Commonwealth Edison
One First National Plaza, Chicago, Illinois
Address Reply to: Post Office Box 767
Chicago, Illinois 60690

Subject: Dresden Station Units 2 and 3
FSAR Update Concerning High
Density Spent Fuel Rack
Installation
NRC Docket Nos. 50-237/249

SECTION 10

AUXILIARY AND EMERGENCY SYSTEMS10.1 FUEL STORAGE AND FUEL HANDLING

FIGURE 10.1.2:1 STAINLESS STEEL TUBE WITH BORAL CORE FOR HIGH DENSITY SPENT FUEL RACKS

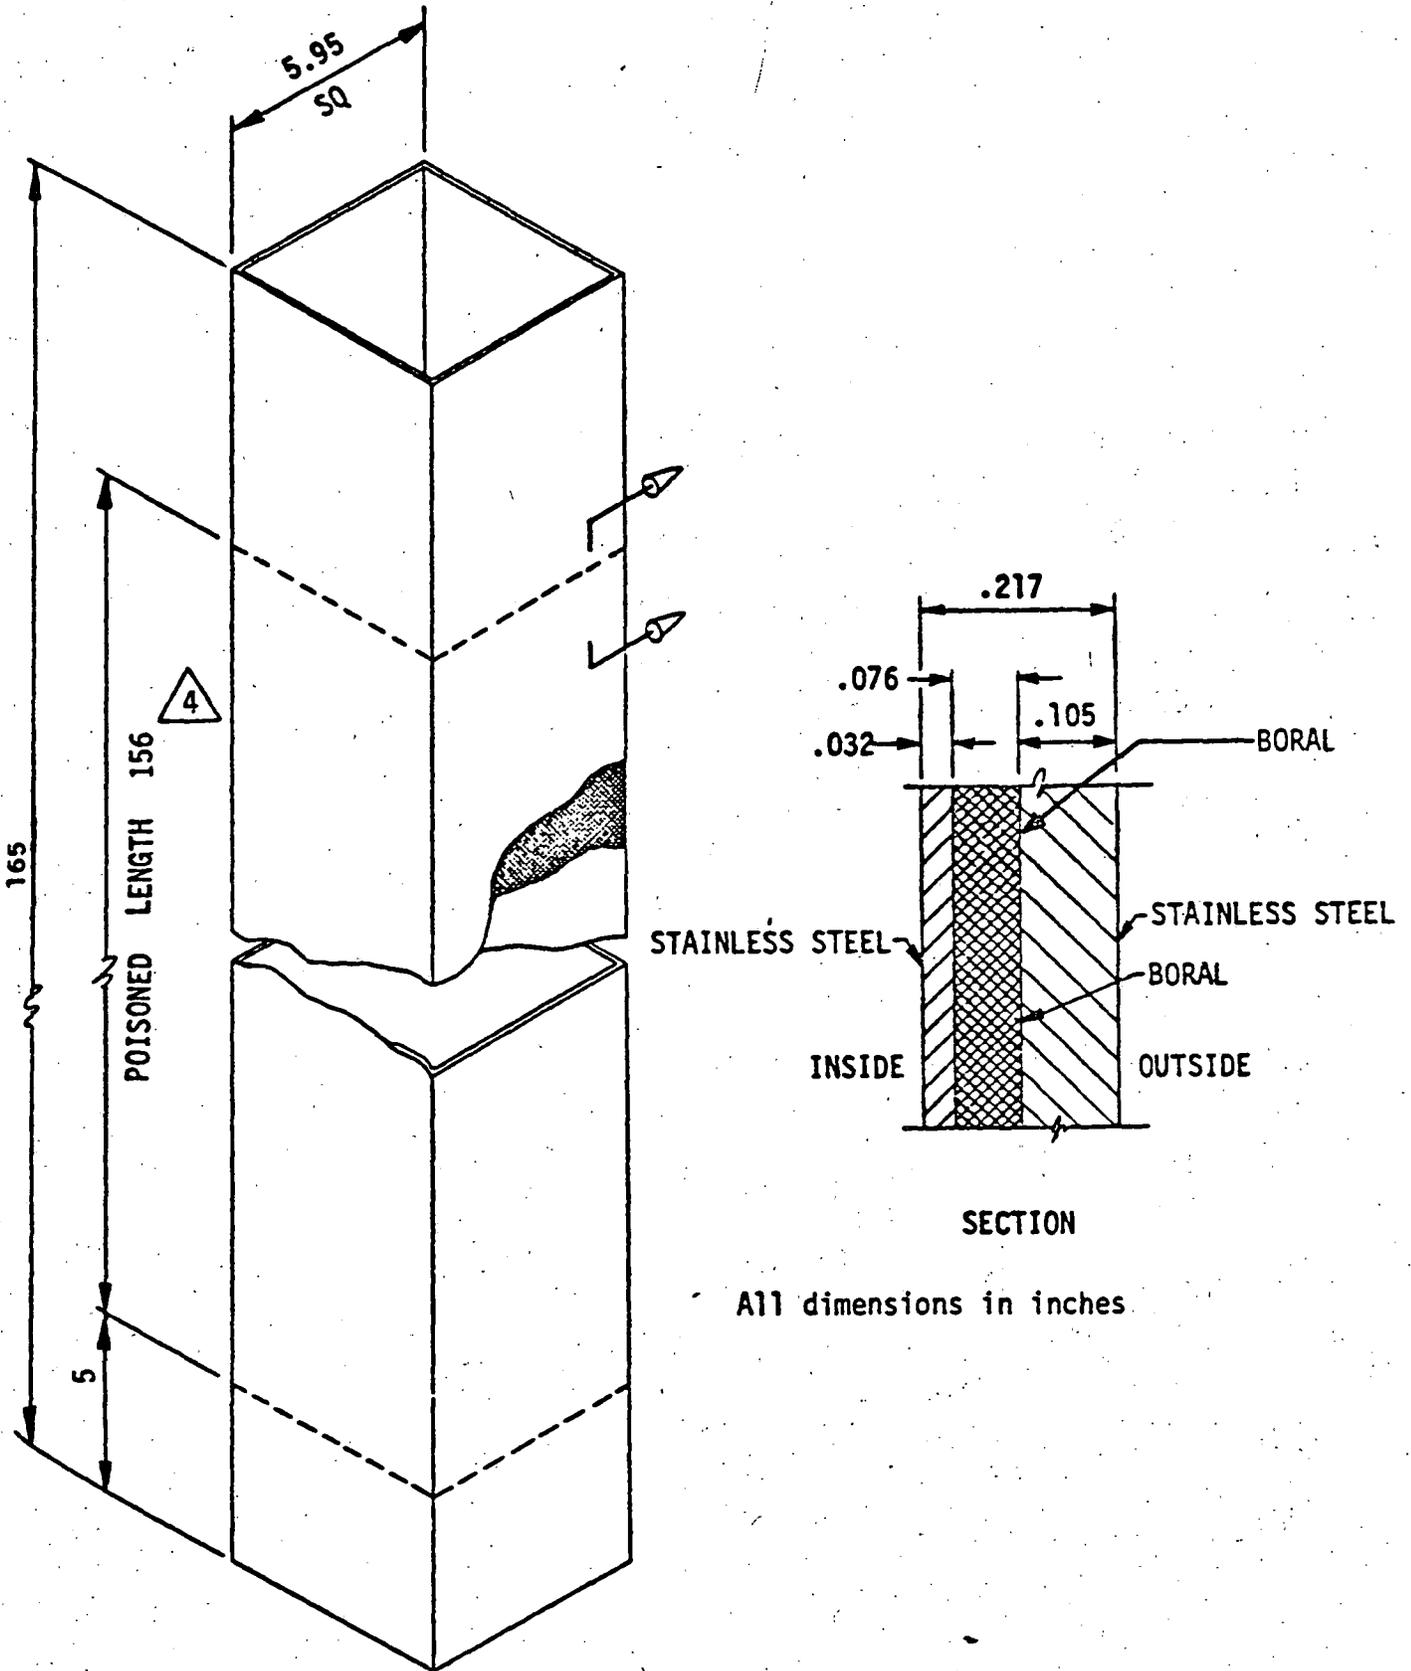
To increase the spent fuel storage capacity of the pool, 33 new high density spent fuel storage racks (see Figures 10.1.2:1 through 10.1.2:3) will be installed in each pool. This will allow the storage capacities of the spent fuel pools to be increased from 1400 fuel assemblies for Unit 2, and from 1420 fuel assemblies for Unit 3, to 3537 fuel assemblies for each pool. The fuel pool cooling water sparger has been modified to eliminate interference with placement of the high density racks. Approximately the bottom half was removed so that now the sparger extends only to a depth slightly above the top of the high density racks. An analysis of the convective cooling in the pool with the shortened sparger was made by NSC¹ to confirm that sufficient circulation would/will still be provided.
